Access Compliance Report Public Rights-of-Way (Curb Ramps)

Intersection ID: 10031454 Main Street: MCDONALD_AV Cross Street: N/A Location: S

ADA ID: E7DB2BA5BF08 Ramp Type: Combination2 Initial Pass/Fail: Fail Overall Compliance: No Severity Score: 50

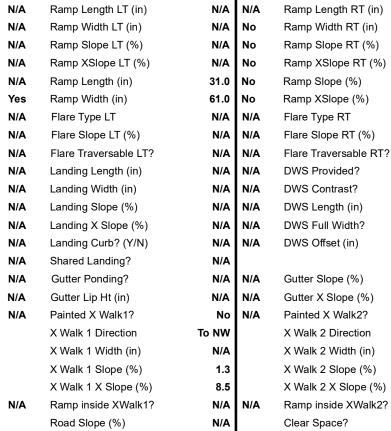
Not Found, R304.5.1, R304.2.2, R304.5.3, R304.3.2

Remove & Replace Entire Ramp.
